UNITED STATES
NUCLEAR REGULATORY COMMISSION
WASHINGTON, D.C. 20555-0001

SUBJECT: TECHNICAL REVIEW: UPDATE ON PROJECTED TECHNETIUM
RELEASE FROM SALTSTONE

Technical Review: Update on Technetium-99 Release from Saltstone

The purpose of this NRC staff Technical Review Report (TRR) is to update the NRC technical position on Technetium (Tc) release from Saltstone at the U.S. Department of Energy (DOE) Savannah River Site (SRS) Saltstone Disposal Facility (SDF). The NRC staff technical position on Tc release had previously been described in two TRRs:

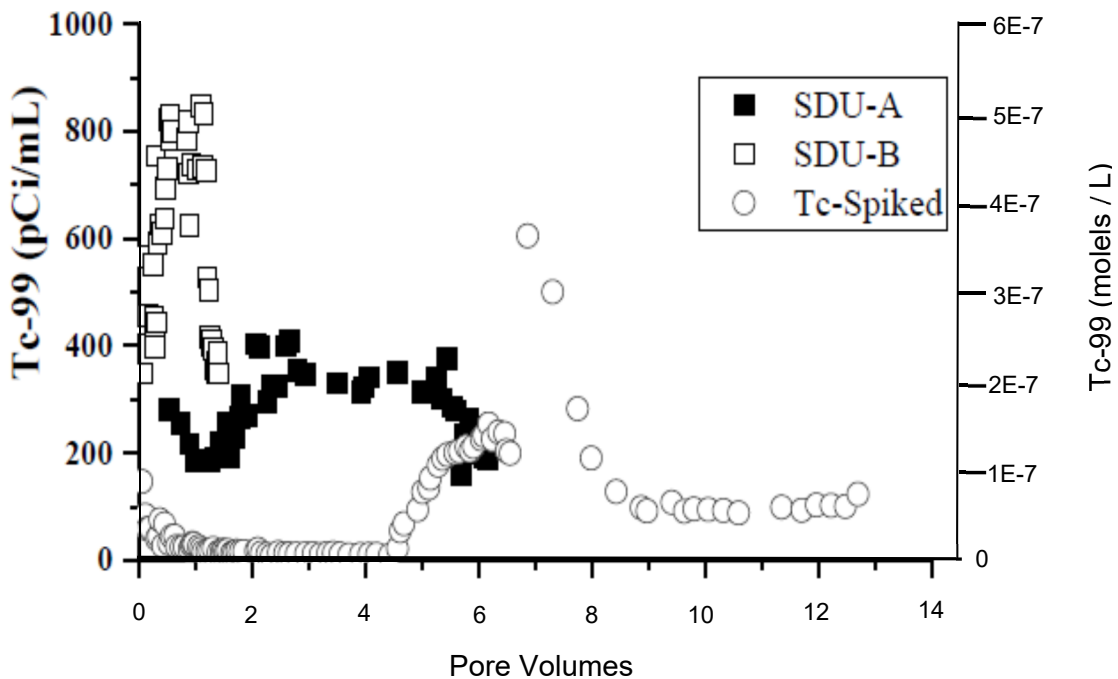
As shown in Figure 3, measured Tc concentrations from dynamically-leached samples of SDS 2A cores exceeded 1×10^{-7} mol/L for both core samples and exceeded 3×10^{-7} mol/L for one core sample, reaching approximately 5×10^{-7} mol/L. Furthermore, it is unclear to the NRC staff whether the Tc permeate concentrations shown in Figure 3 bound the concentrations that would occur in the field. The authors of study documented in SREL DOC No. R-16-0003 suggested that the greater Tc concentrations in permeate from the two cores of field-emplaced saltstone as compared to the permeate from the laboratory-made Tc-spiked sample could be attributable to the slower flow rate through the cores of field-emplaced saltstone. That phenomenon, referred to as a “residence time effect,” has been observed in a study of crushed saltstone (Pabalan et al., 2012) as well as a study of an intact sample of laboratory-made simulated saltstone leached with the DLM process (Accession No. ML17221A038). In both of those studies, a period of stopped flow (i.e., longer residence time) was associated with a marked increase in Tc concentrations in the permeant when the flow was resumed.

Another potential source of differences in the results of the batch and flow-through tests is the liquid-to-solid ratio used in the batch test, and the resulting physical averaging of releases that may occur in the first few pore volumes. As previously described, releases from the first few pore volumes cannot be neglected because the DOE projects the first few pore volumes of flow through saltstone will take place over several thousand years after site closure (see Figure 5). The batch test in SRNL-STI-2016-00106, which also used cores from SDS 2A, used 1 g grout and 10 mL fluid. For comparison, based on a porosity of 0.6 and a dry bulk density of saltstone of 1.01 (SRR-CWDA-2014-00006), the liquid-to-solid ratio in 1 pore volume of saltstone is 1.5 mL fluid/g grout. Based on that value, the liquid-to-solid ratio used in STI-2016-00106 represents the same liquid-to-solid ratio as approximately 6.7 pore volumes of fluid flowing through an intact grout sample. Therefore, increases and decreases in Tc concentration that happen over fewer pore volumes (e.g., the factor of two increase and decrease that occurred within the first two pore volumes for sample SDU-A, as shown in Figure 3) will not be observable in the results of batch testing. In general, physical averaging should be accounted for when comparing the results of a batch test and studies based on a dynamic leaching procedure. However, in the specific case of the dynamic leaching results reported in SREL DOC No. R-17-0005 and the batch results reported in SRNL-STI-2016-000106, averaging does not explain the order of magnitude difference between the Tc concentration in the batch test (i.e., 2×10^{-8} mol/L) and the average of the first six pore volumes in the dynamic leaching procedure (i.e., approximately 2×10^{-7} mol/L) (see Figure 3).

In contrast, the concentration of Tc released from field-emplaced saltstone that the DOE attempted to maintain in a chemically reduced state is approximated at 5×10^{-7} mol/L (see Figure 3).

Dynamic leaching of cores of field-emplaced saltstone (see Figure 3) provides model support for assumptions about releases from saltstone pores (i.e., volumetric as opposed to surface releases) at very early times (i.e., the first few pore volumes). Although the data shown in Figure 3 do not address the existence of a persistent oxidized fraction of Tc in saltstone with direct spectroscopic evidence, those data do provide information about Tc mobility in intact portions of field-emplaced saltstone. Figure 3 provides support for the determination that, whether or not there is a “persistent oxidized fraction” of Tc initially present in saltstone, it does not appear to lead to elevated Tc concentrations in the first pore volume of liquid to be transported through saltstone, as hypothesized in both the NRC 2013 SDF Monitoring Plan technical notes supporting MF 5.05 and the Oxidation TRR. As shown in Figure 3, one of the samples tested did not show elevated concentrations in the first few pore volumes, and the other sample showed releases elevated by approximately a factor of two between the first and second pore volume. However, the authors of the data shown in Figure 3 subsequently analyzed it as a function of pH (SRR-CWDA-2017-00085) and determined that the releases were consistent with the DOE conceptual model that Tc release from reduced saltstone is governed by the solubility of $TcO_2 \cdot 1.6 H_2O$ or $TcO_2 \cdot 2 H_2O$ (see Figure 8) and therefore, do not appear to indicate releases from a “persistent oxidized fraction” of Tc. The importance of including the relevant chemical conditions of Tc release, including pH and Eh, is described in the Solubility TRR and is reviewed in this TRR in the context of MF 5.01.

The mechanism of rinse-release suggested by the authors of PNNL-24297 is consistent with the lack of significant rinse-release from the cores of field-emplaced saltstone (see Figure 3), because the cores featured in Figure 3 were internal to the saltstone monolith during curing and would not have experienced the same surface accumulation of evaporation salts that samples cured in a laboratory would have. Therefore, although the results from cores of field-emplaced saltstone (see Figure 3) provide strong model support regarding the flush of the first pore volume through saltstone, those results do not directly address surface rinse-release because those cores were taken from inside the saltstone monolith.

Figure 5. Number of pore volumes projected to migrate through saltstone grout for each disposal structure (based on data from the DOE PORFLOW model files).

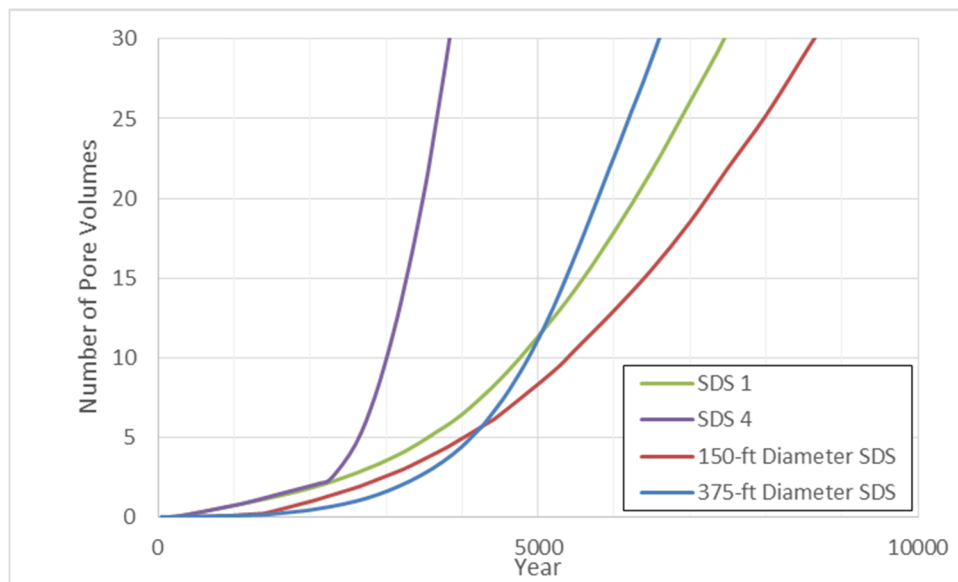
Recent research provides model support for the conceptual model that Tc release from field-emplaced saltstone is not insensitive to trace quantities of oxygen. One line of support for that conceptual model is the similarity of the releases from the two cores of field-emplaced saltstone (see Figure 3) despite one being leached with deaerated liquid and the other being leached with liquid equilibrated with laboratory air for more than one pore volume (i.e., two pore volumes for one sample and six pore volumes for the other sample). As shown in Figure 5, the DOE

projected that number of pore volume replacements in field-emplaced saltstone would take thousands of years after site closure. Therefore, the NRC staff determined that the observed behavior is relevant, at a minimum, to a significant fraction of the 10,000-year period after site closure. The similarity of those releases supports a model in which minor exposures to oxygen do not cause significant Tc release, in contrast with the conclusions of the prior studies that were reinterpreted earlier in this section of this TRR.

Figure 6. Relationship between Tc solubility and pH for several Tc solid phases (from SREL DOC No. R-17-005 Figure 1)

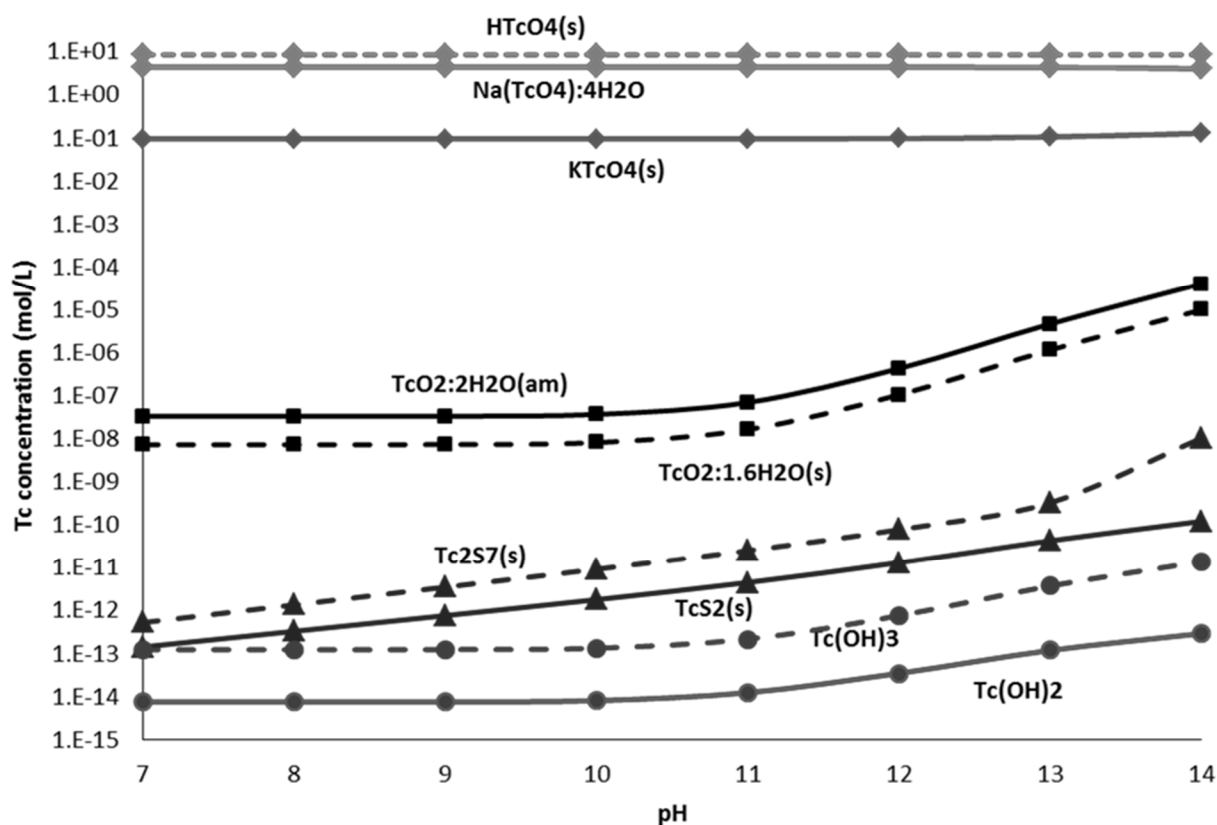
As shown in Figure 6, pH values greater than 10.5, which correspond to “young” cementitious material, are expected to have Tc solubilities greater than 1×10^{-7} mol/L. Although the authors of the study documented in SREL DOC No. R-17-0005 expressed concern about the reliability of

pH measurements of the permeant from cores of emplaced saltstone because of the small sample volumes used, the measured Tc concentrations of approximately 1×10^{-7} mol/L to 6×10^{-7} mol/L (see Figure 3) were consistent with the projected Tc solubility limits in young cementitious material (see Figure 6). Thus, it appears that recent research results are consistent with thermodynamic projections of the solubility of $\text{TcO}_2 \cdot 1.6\text{H}_2\text{O}$ or $\text{TcO}_2 \cdot 2\text{H}_2\text{O}$ under the expected conditions of young cementitious material. If the conditions of young cementitious material last for between 10 to 50 pore volumes, as the DOE previously projected (SRR-CWDA-2016-00004), and if it takes between 3,000 to 5,000 years after site closure for 10 pore volumes to pass through saltstone, as the DOE projects in the 2014 Evaluation Case, then the Tc concentrations released from cores of field-emplaced saltstone would be relevant to projections of Tc release for several thousand years after site closure.

Figure 7. Eh and pH of permeant passed through cores of field-emplaced saltstone with a dynamic leaching procedure relative to expected boundary between oxidized and reduced Tc (from SRR-CWDA-2017-00085 Figure 12)

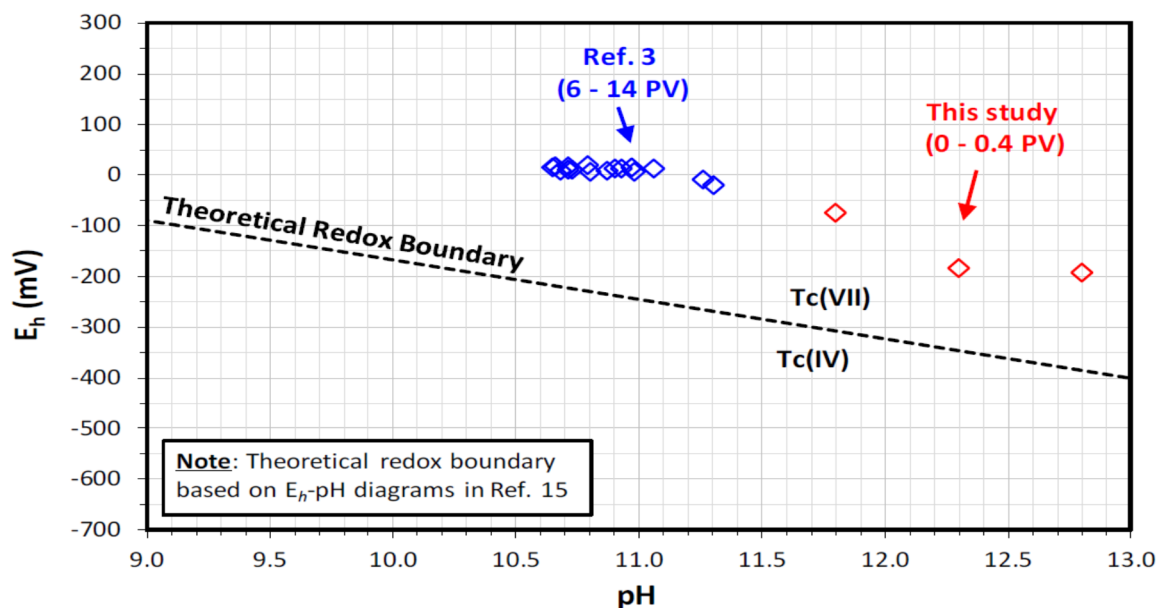
There are several potential interpretations of the comparable Tc releases from the two cores of field-emplaced saltstone shown in Figure 3. In a subsequent work that continued to evaluate the data shown in Figure 3, in addition to new data from the same core samples (SRR-CWDA-2017-00085), the authors showed that the measured Eh of the permeant solution would suggest that the Tc should be in the oxidized state (see Figure 7).

Figure 8. Observed Tc concentrations and calculated solubility as a function of pH (from SRR-CWDA-2017-00085 Figure 11)

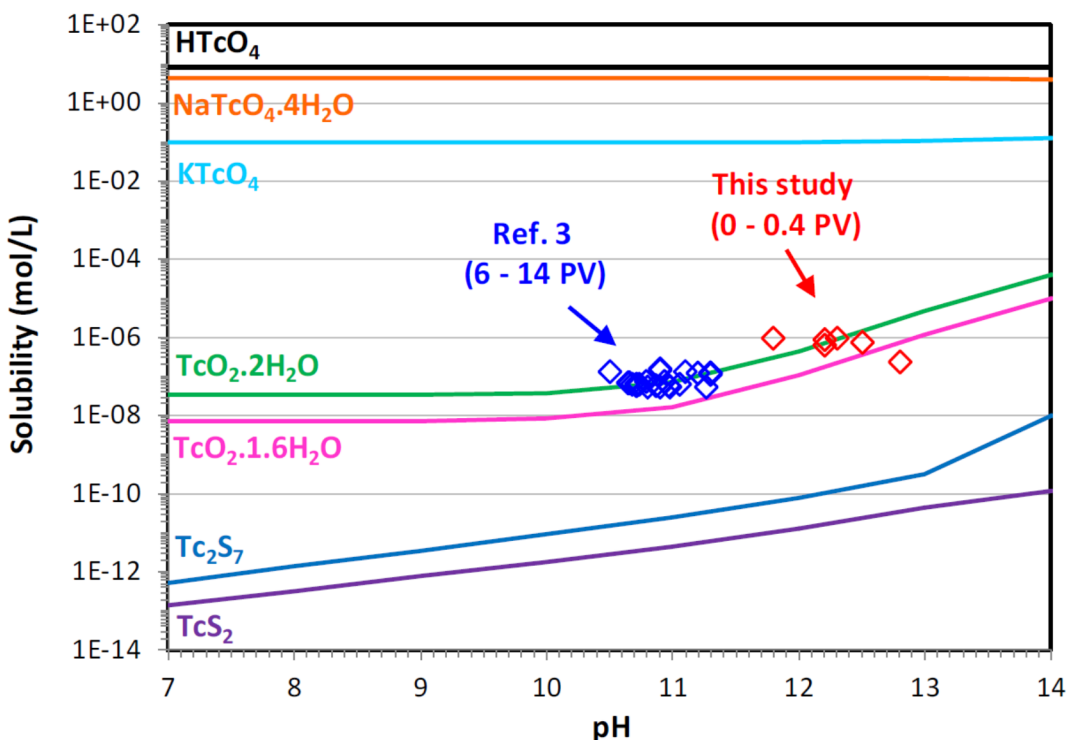
The authors indicated that that result was unexpected, especially given the consistency between the observed Tc concentrations in the permeant with the projected solubility of the reduced-Tc solid phase $TcO_2 \cdot 2H_2O$ (see Figure 8). The authors of the study that was documented in SRR-CWDA-2017-00085 questioned whether the measured Eh of the permeant accurately reflected the Eh experienced by Tc in the pore solutions throughout the samples. The NRC staff agrees that the question is significant to understanding Tc behavior in the saltstone system.

Figure 9. Projected Tc flux from future SDS 9 as a function of assumed saltstone reducing capacity and Tc solubility in reduced saltstone (from SRR-CWDA-2016-00004, Rev. 1 Figure SP-2.9)

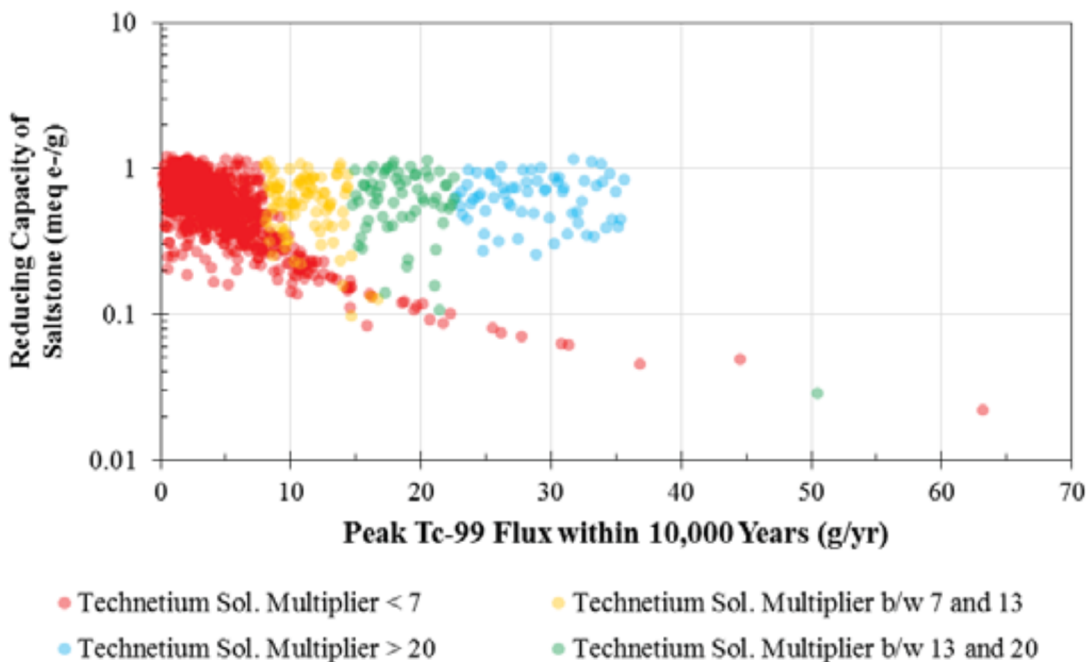
As illustrated by the distinct bands of color in Figure 9, the modeled solubility of Tc in reduced saltstone has a clear effect on the model outputs in the Tc-Ox uncertainty analysis. The effect of saltstone reducing capacity is only evident where it is lower than approximately 0.2 meq e-/g grout. That result makes sense to the NRC staff because the reducing capacity of saltstone controls how much saltstone is oxidized by a given influx of oxygen. Therefore, below some value of residual reducing capacity, saltstone is projected to be oxidized fast enough that Tc releases from the fraction of saltstone oxidized each year contribute most significantly to the overall projected Tc release. In contrast, above some value of the reducing capacity, the amount of saltstone oxidized in a year is simply too small for releases from the oxidized fraction to be significant compared to releases from the larger volume of reduced saltstone, even though Tc is projected to be released more rapidly from oxidized saltstone than it is from an equal volume of reduced saltstone.

Figure 13. Projected Tc release from a 150-foot disposal structure for three different Tc solubilities in reduced saltstone, with disposal structure concrete either initially completely oxidized or initially completely reduced (from SRR-CWDA-2013-00062 Figure 5.6-81)

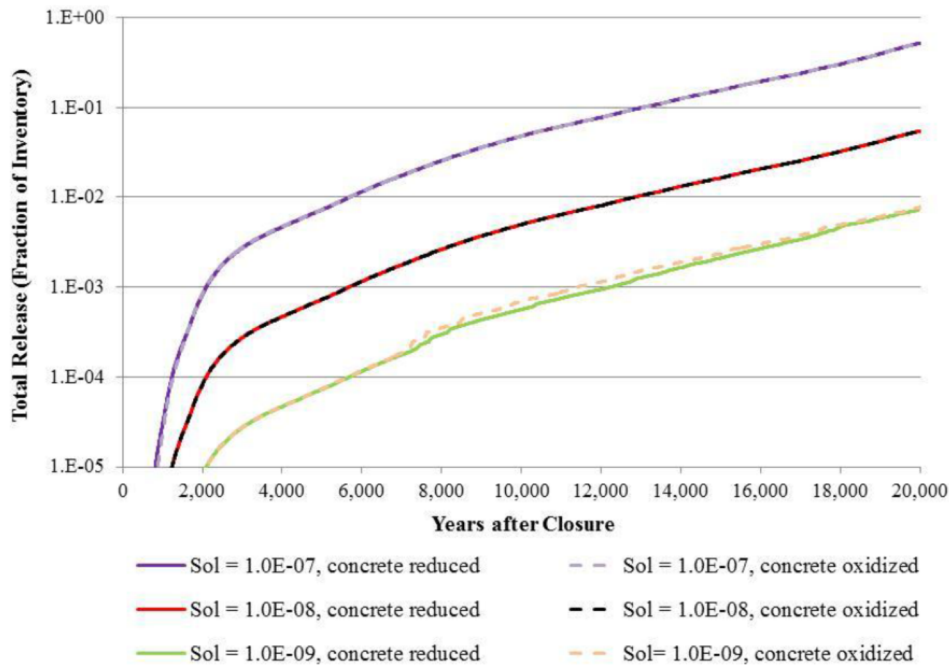
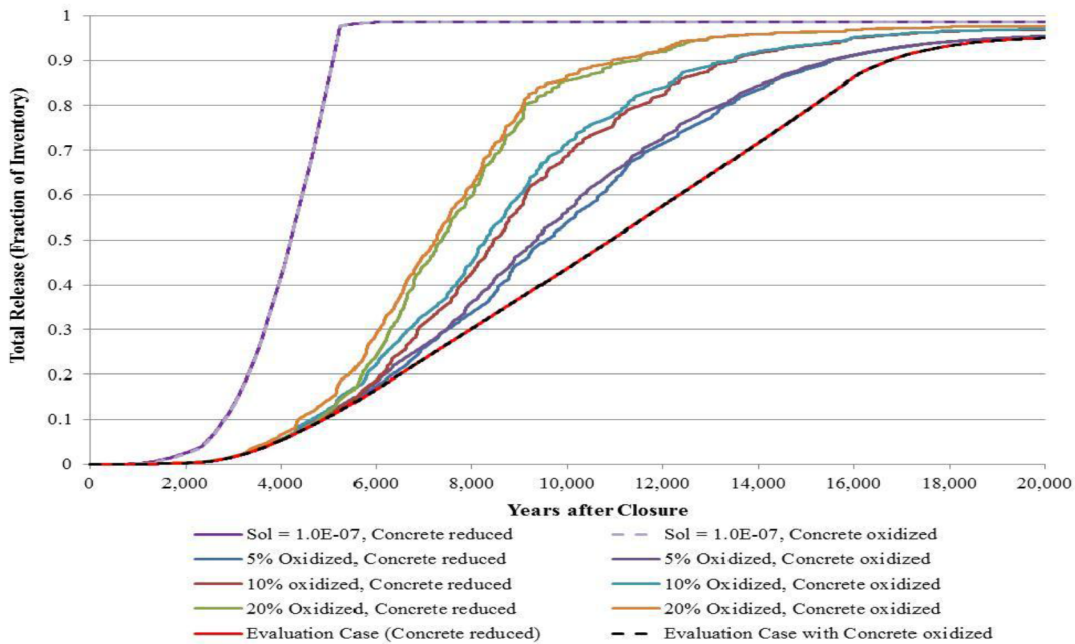
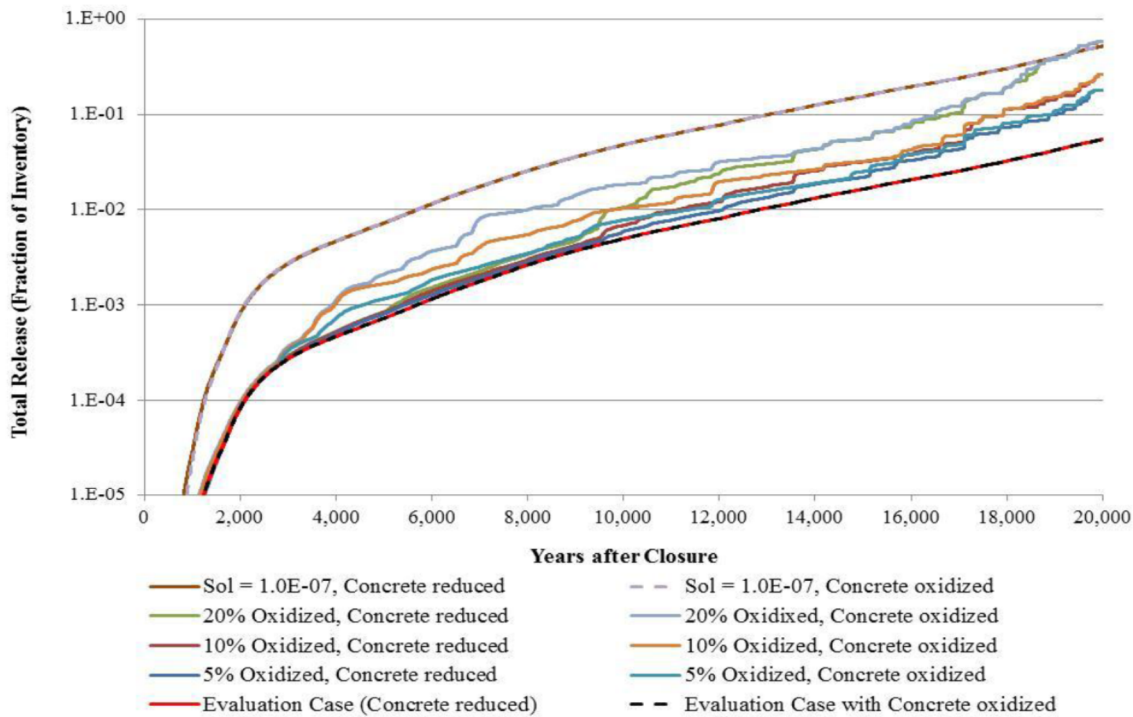
As shown in Figure 13, Figure 14, and Figure 15, the reduction in the Tc release rate attributable to retention in the disposal structure concrete is negligible in the 2013 Evaluation Case and minimal or limited in the relevant sensitivity analyses. Although the DOE did not repeat those sensitivity analyses with the models that the DOE used to support the FY 2014 Special Analysis Document, the NRC staff expects the results would be similar because Tc release model for 2014 Evaluation Case is very similar to the Tc release model for the 2013 Evaluation Case. Specifically, both models represent Tc release from chemically reduced

Figure 18. Residual reducing capacity in two samples of simulated Cast Stone as a function of depth from a surface exposed to air for 50 days (sample Tc2) or 68 days (Sample labeled “Cr500-2”) (from SRNL-STI-2013-00541 Figure 3-4)

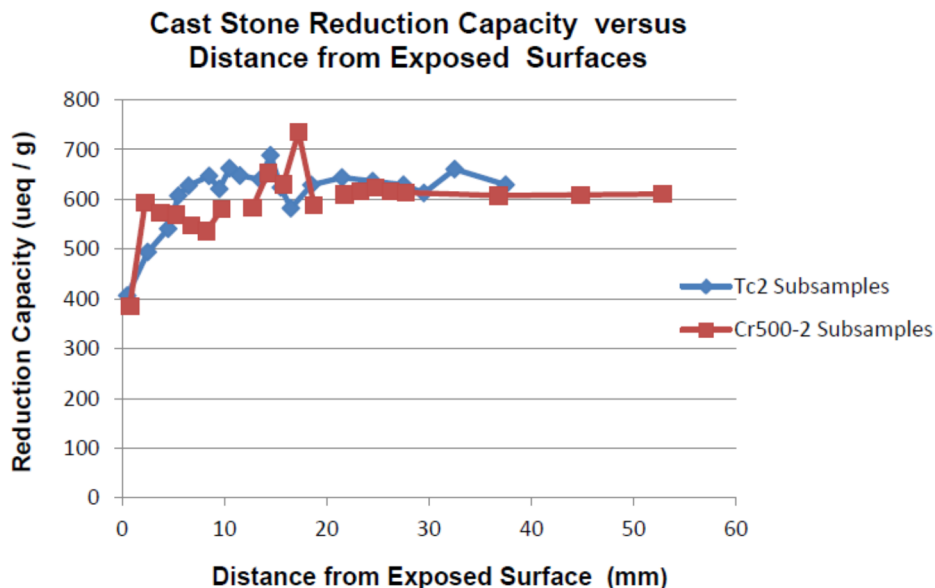
Figure 18 appears to show a depletion of reducing capacity in approximately the first 5 mm of the sample, as measured from the exposed surface. The authors compared that result to Figure 17, which shows elevated fractional releases extended approximately 17 mm from the exposed surface. Based on that comparison, the authors drew the conclusions that residual reducing capacity was not a good predictor of Tc mobility and Tc could be mobile in areas of the sample that still had residual reducing capacity. The authors still attributed the increased Tc mobility to Tc oxidation from Tc(IV) to Tc(VII). To explain the difference between the measured depth of the depletion of residual reducing capacity versus the “Tc-specific oxidation front,” as measured by fractional Tc releases, the authors hypothesized that oxygen preferentially reacted with Tc to oxidize it before consuming the reducing capacity in the area.
